# MEMO

**To:** Mary Osman  
**From:** Mark Pisani  
**Date:** 17 December 2021  
**Subject:** Application No: Not Provided  
Description: Big Housing Build (Richmond)  
Site Address: 147-161 Elizabeth Street, Richmond

I refer to the above Planning Application received on 29 November 2021 in relation to the proposed Big Housing Build at 147-161 Elizabeth Street, Richmond. Council's Engineering Referral team provides the following information:

### LEWIS COURT - AERIAL PHOTO IMAGE

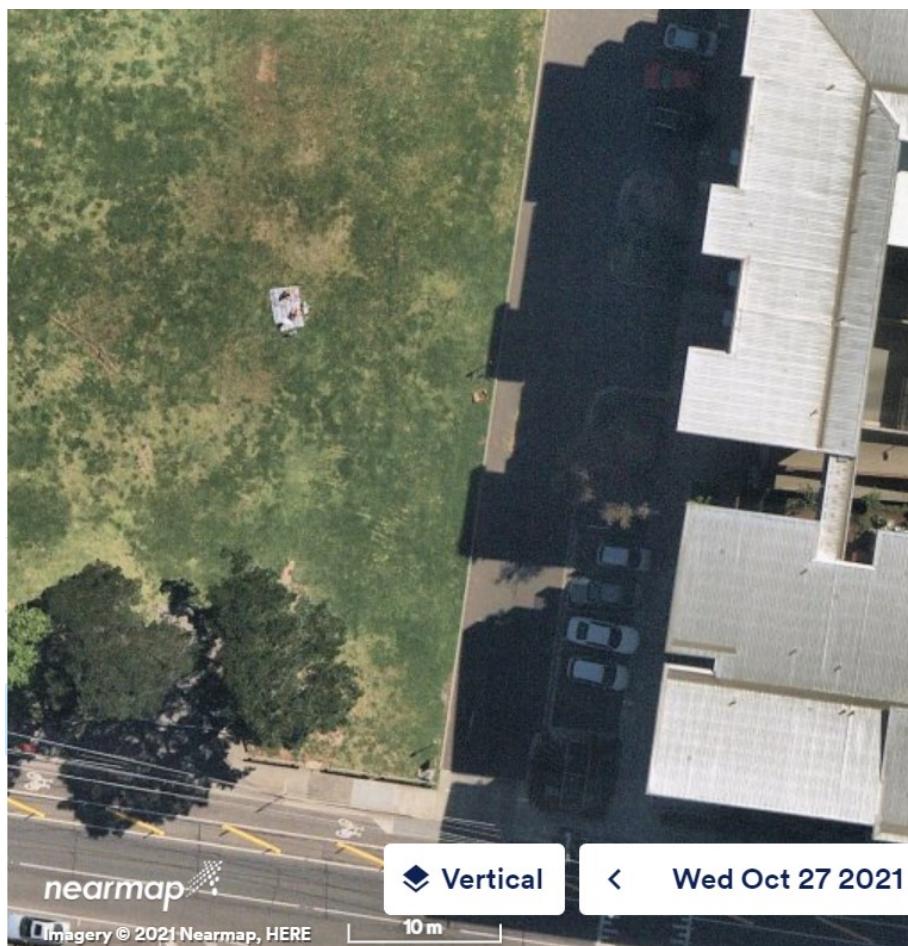
Left: No footpath has been provided on the west side of Lewis Court. As Lewis Court is a private road, the applicant is to confirm footpath construction and arrangements to be made with the owner/manager of the road.

Construction of Footpath	Details of the provision of a footpath on the eastern side of the development should be provided by the applicant. As Lewis Court is a private road, the applicant would confirm the arrangements for the construction of a footpath abutting the eastern boundary of the site from the owner/manager of the road. The width and cross-fall of the footpath should satisfy DDA requirements that are normally applied for new footpaths on public roads.
